MWO 9-2320-272-20-6

FUEL TANK VENTILATION KIT
MODIFICATION WORK ORDER

MODIFICATION OF 5-TON
M939 AND M939A1 SERIES TRUCKS

FIGURE 1

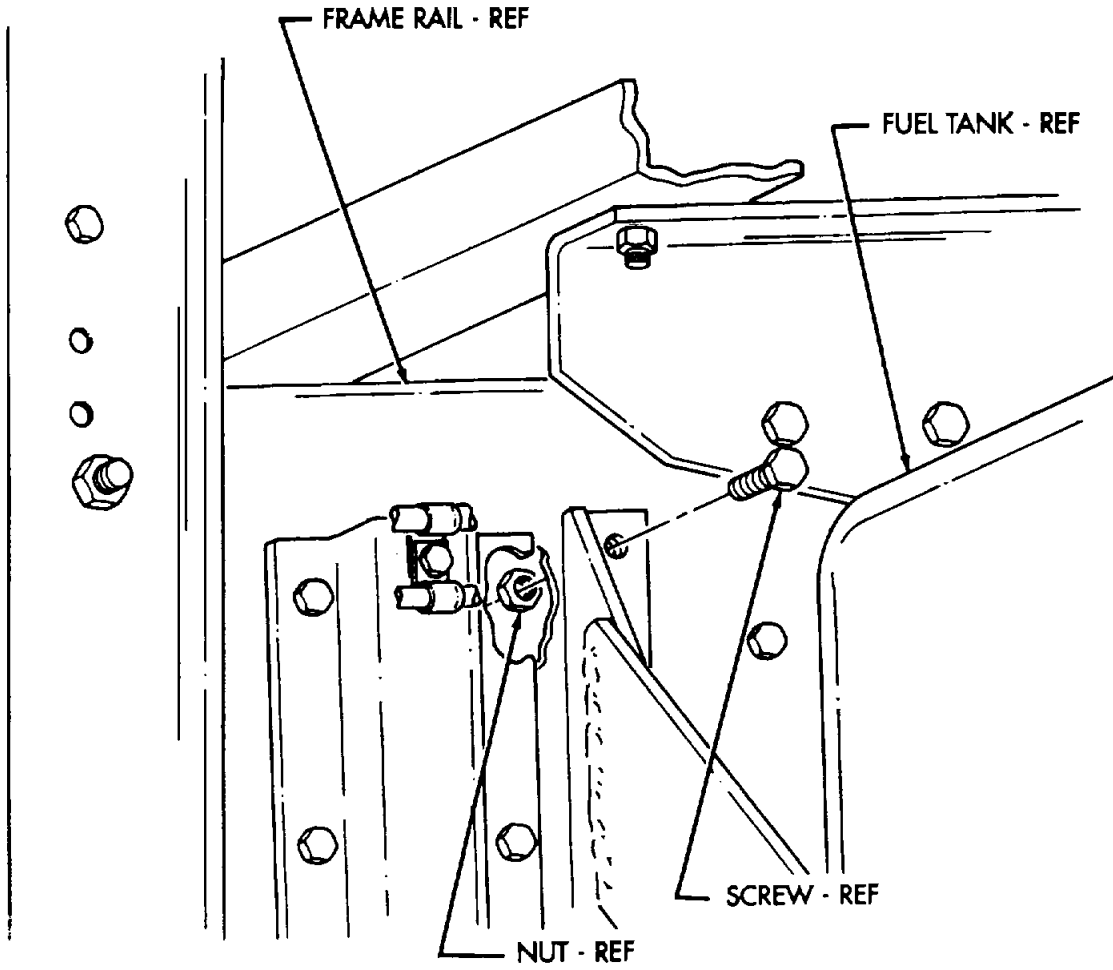
- (1) Disconnect battery ground cables (TM 9-2320-272-20-1).
- (2) Remove tachometer pulse sender unit (TM 9-2320-272-20-1).
- (3) Remove nut and screw from frame rail as shown in figure 1. Set nut and screw aside for disposition per para. 8.

FIGURE 2

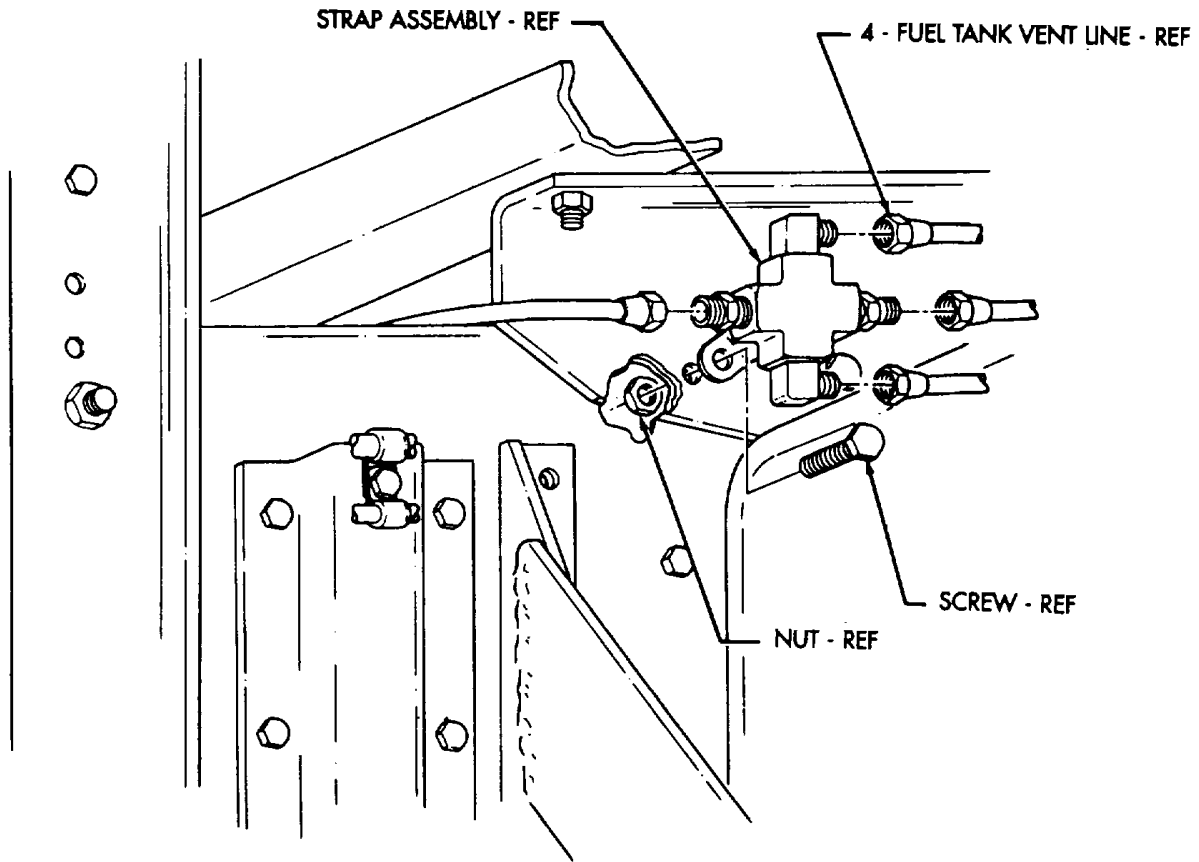
- (4) Disconnect four vent lines from strap assembly as shown in figure 2.
- (5) Remove nut, screw, and strap assembly from frame rail as shown in figure 2. Set nut, screw, and strap assembly aside for disposition per para. 8.

FIGURE 3

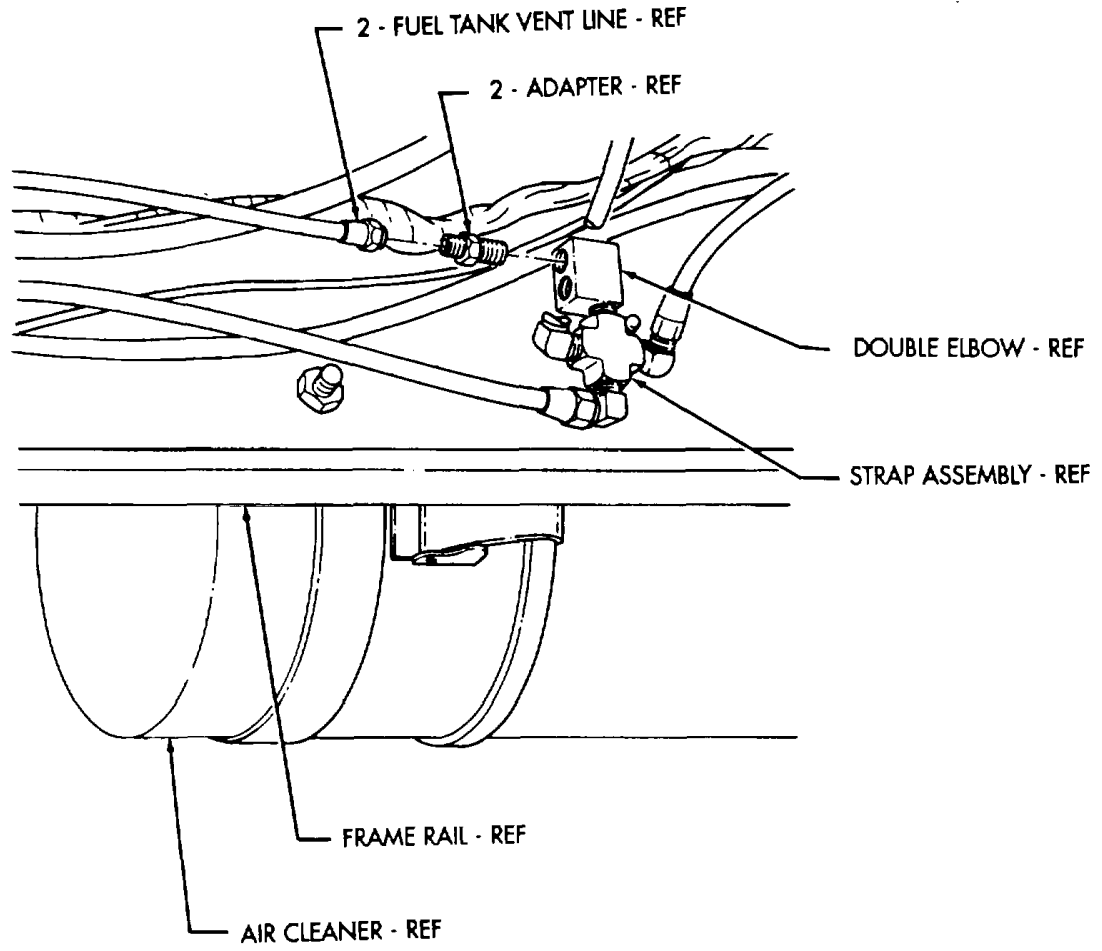
- (6) Remove two fuel tank vent lines and adapters from double elbow connected to strap assembly on inside frame of rail, opposite air cleaner as shown in figure 3. Set adapters aside for disposition per para. 8.

FIGURE 4

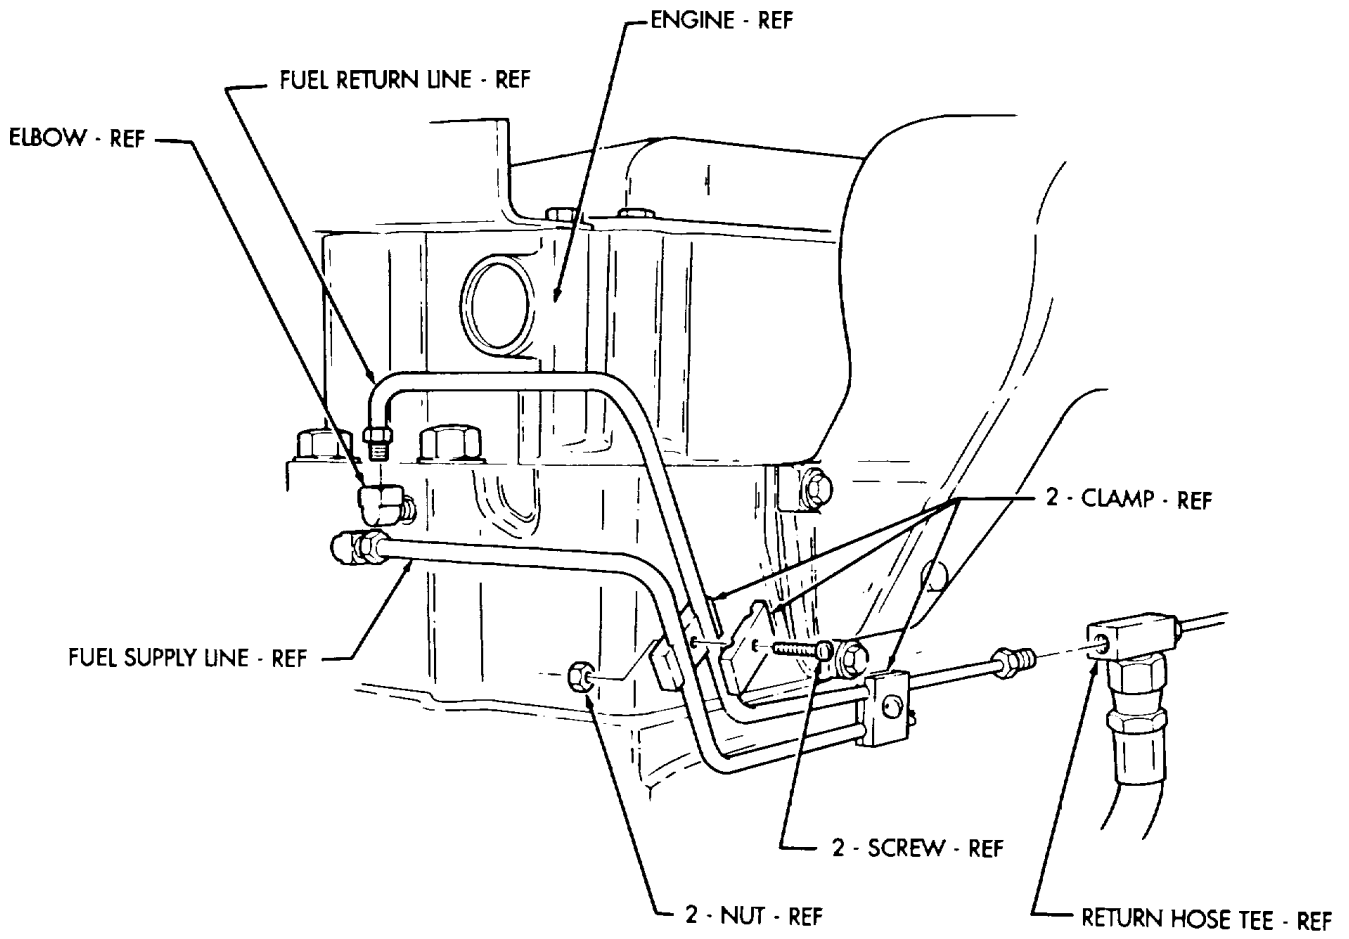
- (7) Remove two nuts, screws, and clamps from fuel return line and fuel supply line as shown in figure 4. Retain nuts, screws, and clamps for installation.

- (8) Disconnect fuel return line from return hose tee and elbow on front of engine as shown in figure 4.

FIGURE 5

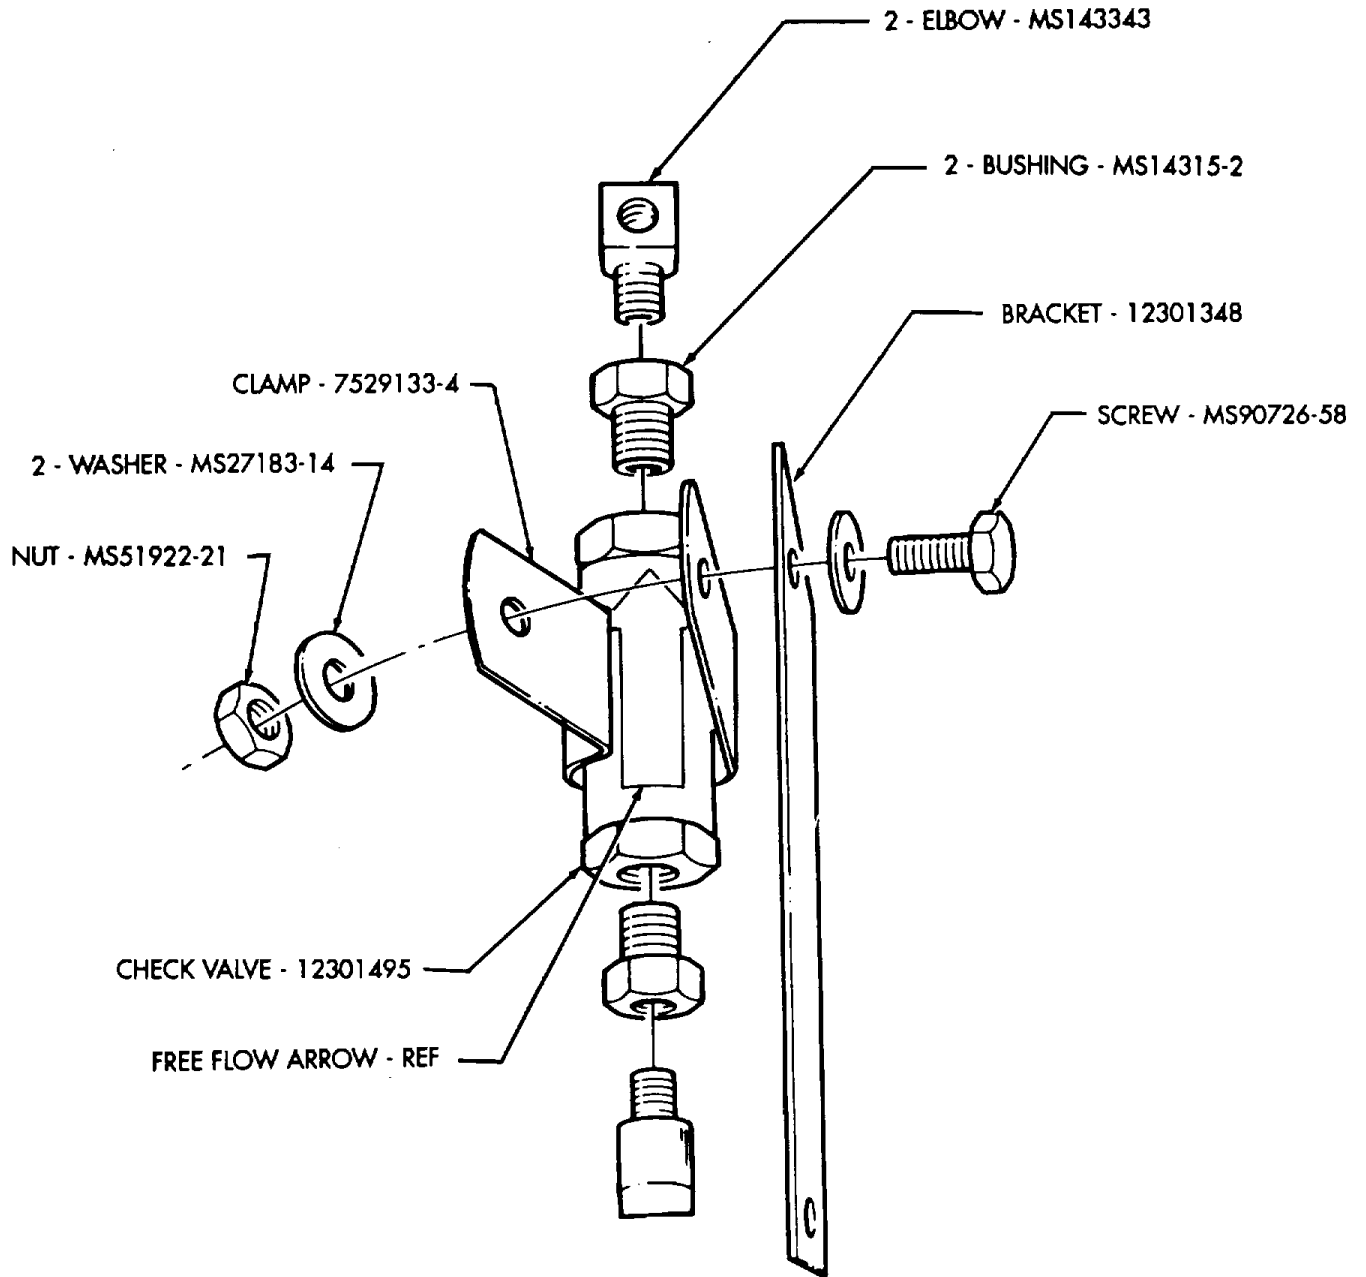
- (1) Install two MS14315-2 bushings in 12301495 check valve as shown in figure 5.

- (2) Install two MS143343 elbows on bushing as shown in figure 5.
- (3) Install 7529133-4 clamp on check valve as shown in figure 5.

- (4) Install check valve on 12301348 bracket with MS90726-58 screw, two MS27183-14 washers, and MS51922-21 nut as shown in figure 5. Ensure free flow arrow on check valve points up.

FIGURE 6
14

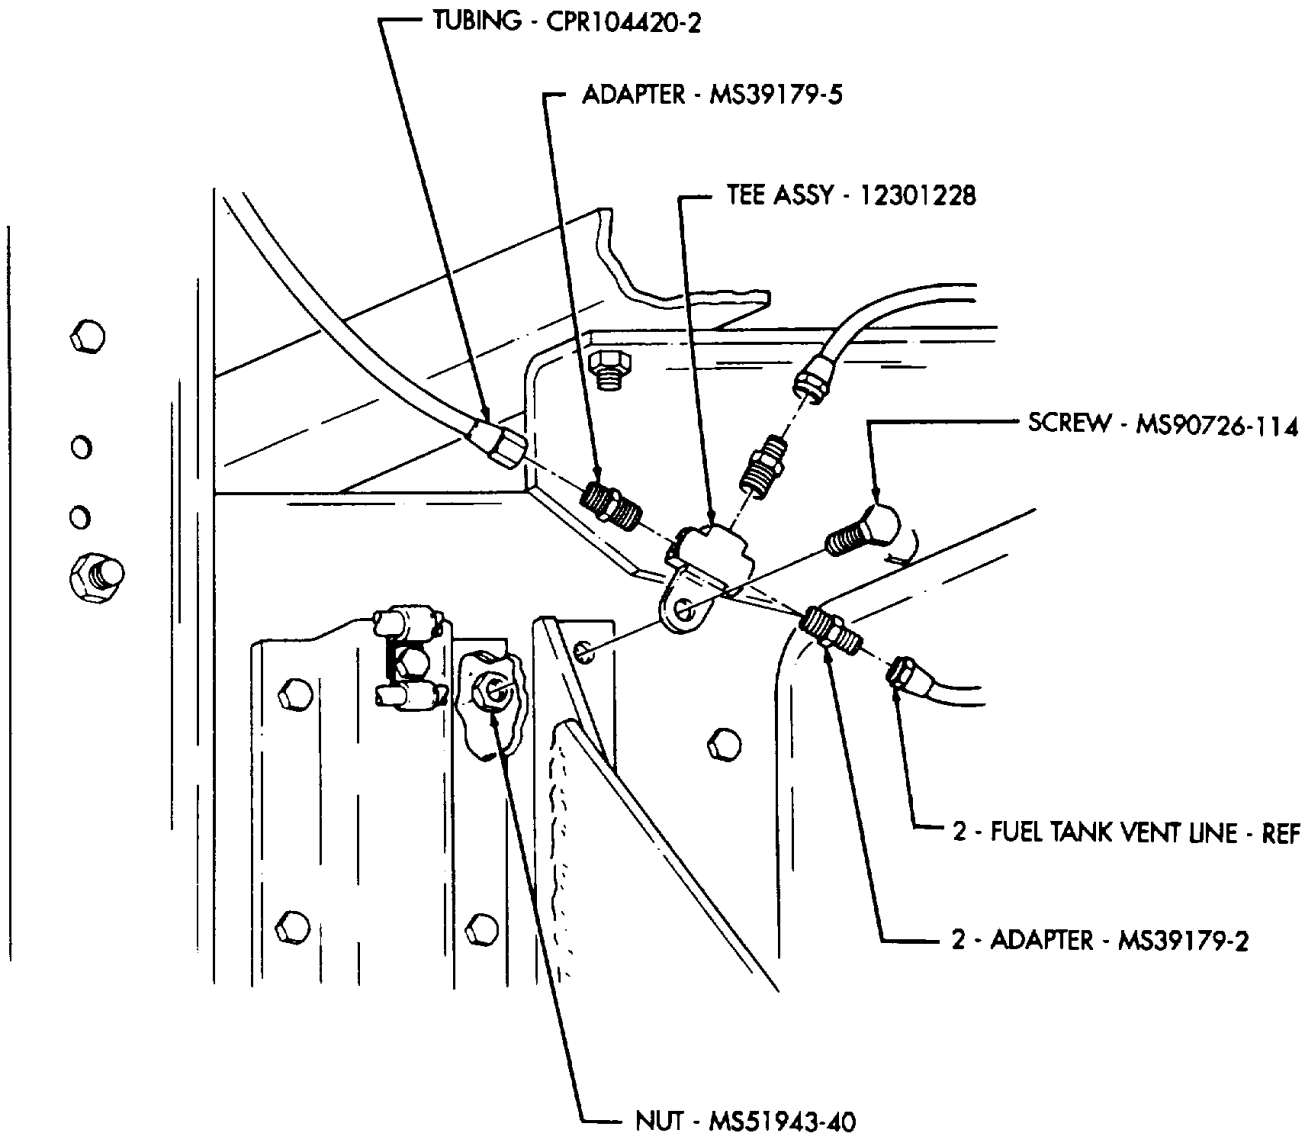
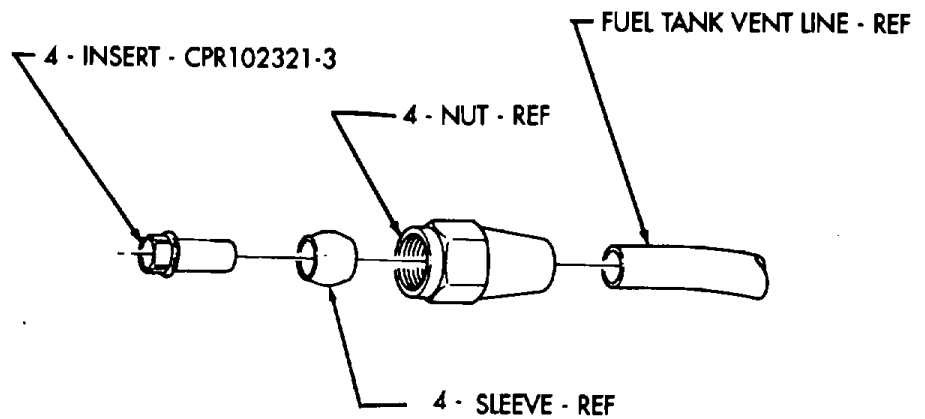
- (5) Install two MS39179-2 adapters on 12301228 tee assembly as shown in figure 6. Retain sleeves and nuts for installation.
- (6) Install two 12255985 double elbows on 12301228 tee assembly as shown in figure 7.

- (3) Connect two fuel tank vent lines from fuel tank-to-tee assembly as shown in figure 6.
- (4) Connect four fuel tank vent lines from fuel tanks-to-tee assembly as shown in figure 7.
- (5) Connect end of CPR104420-2 fuel tank vent line to tee assembly (12301228) as shown in figures 6 or 7.
- (6) Install tube (12301244) on air intake pipe with four MS35842-16 clamps as shown in figure 11. Remove excess clamp ends.
- (7) Connect end of fuel tank vent tubing (CPR104420-2) to tube (12301244) as shown in figure 11.

FIGURE 7

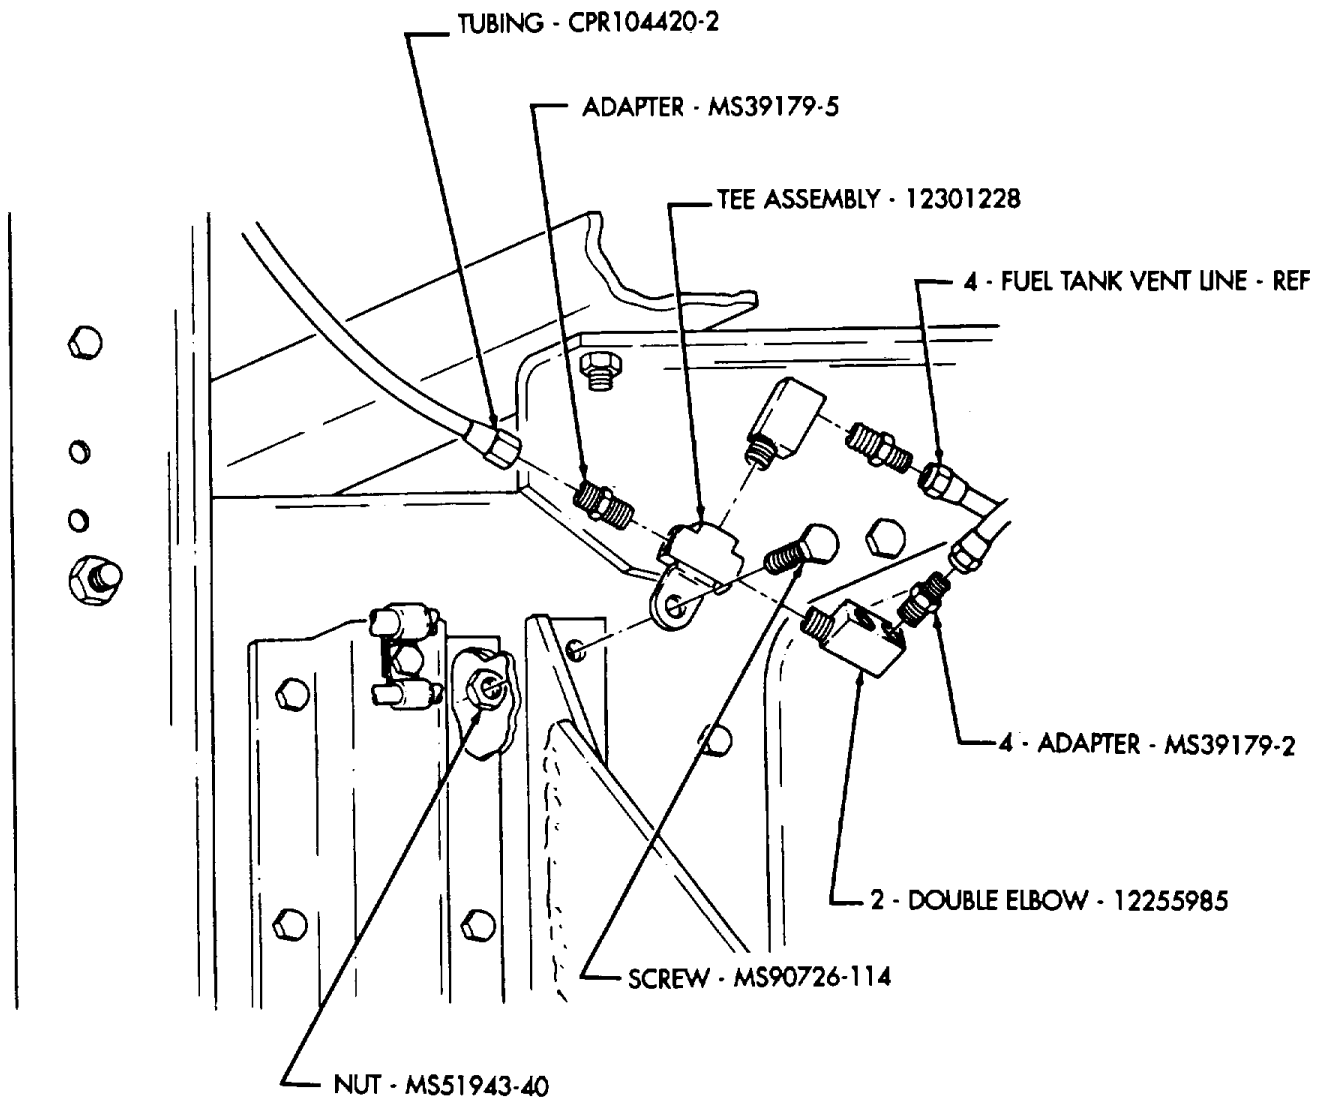
- (7) Install four MS39179-2 adapters on two double elbows as shown in figure 7.
- (8) Install MS39179-5 adapter on tee assembly as shown in figures 6 and 7. Retain sleeve and nut for use in step 12.

- Perform step (3) for vehicles equipped with single fuel tank.
- Perform step (4) for vehicles equipped with dual fuel tanks.
- If vent lines must be cut and shortened, use new nuts, sleeves, and CPR102321-3 inserts as shown in figure 7.
- Four CPR102321-3 inserts are required for vehicles equipped with dual fuel tanks.
